Presented To:	Planning Committee
Presented:	Monday, Nov 04, 2019
Report Date	Tuesday, Oct 15, 2019
Type:	Public Hearings
File Number:	780-6/16002

Request for Decision

J. Corsi Developments Inc. – Application to amend and revise a Draft Approved Plan of Subdivision, Corsi Hill Subdivision, Sudbury

DRAFT PLAN OF SUBDIVISION OF
PART OF LOT 8, CONCESSION 2
AND
BLOCKS 27 & 28
REGISTERED PLAN 53M-1356
GEOGRAPHIC TOWNSHIP OF McKIM
CITY OF GREATER SUDBURY
DISTRICT OF SUDBURY
TERRY DEL BOSCO, O.L.S.
JUNE 3, 2019

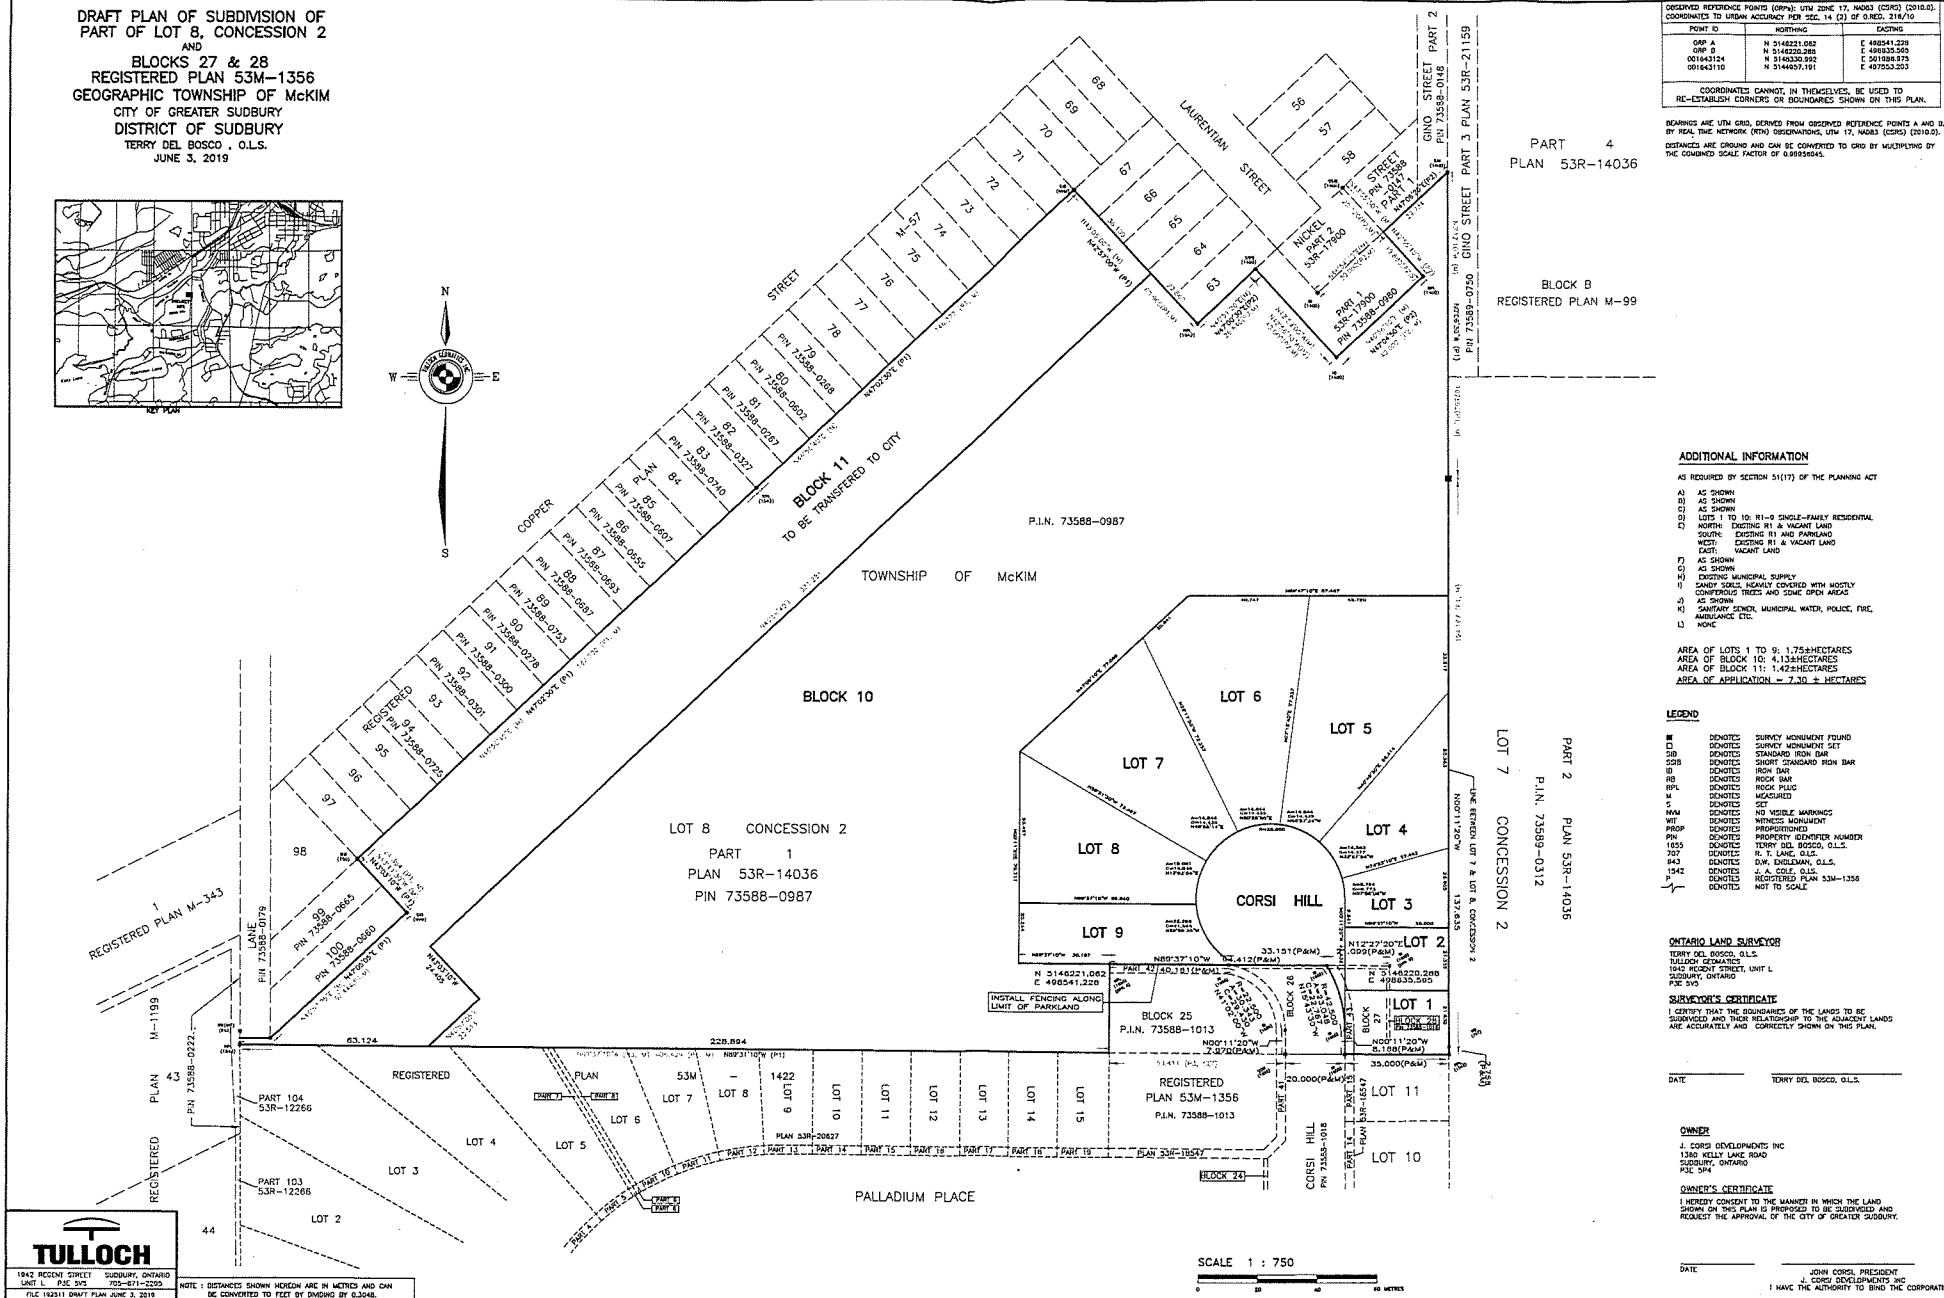
1. By deleting Condition #1 entirely and replacing it with the following:

"1. That this draft approval applies to the draft plan of subdivision of PIN 73588-0987, Part 1, Plan 53R-14036, Except Part 1, Plan 53R-17900 & Plan 53M-1356, Lot 8, Concession 2, Township of McKim, as shown on a plan of subdivision prepared by Tulloch Geomatics Inc. and dated June 3, 2019.", and;

2. By deleting the words "Block 10" in Condition #31 and replacing it with the words "Block 11".

The application to amend the existing draft approved plan of subdivision proposes to reduce a parkland block area that is to be dedicated to the municipality from 5.55 ha (13.71 acres) to 1.42 ha (3.51 acres). The draft approved plan of subdivision will continue to include nine urban residential lots and the number of lots is not proposed to be increased. The draft plan of subdivision was initially approved by Council on January 15, 2018. The draft approved plan was previously supported by staff and approved by Council through concurrent rezoning and draft plan of subdivision applications (Files # 751-6/16-21 & 780-6/16002), which relied upon those policies found under Section 20.7.1 – Comprehensive Planned Unit Developments of the Official Plan for the City of Greater Sudbury. The previous [report](#) addressing the former rezoning and draft plan of subdivision applications is attached to this report for reference purposes.

- That Condition #1 in the existing draft plan approval document be amended to reference the revised plan as being the plan of subdivision prepared by Tulloch Geomatics Inc. and dated June 3, 2019; and,
- That Condition #31 be amended to reference Block 11 as being transferred to the City.

The Planning Services Division therefore recommends that the application to revise the existing draft plan approved subdivision by reducing the size of the open space block to be conveyed to the City from 5.55 ha (13.71 acres) to 1.42 ha (3.51 acres) be approved in accordance with the resolution section of this report.
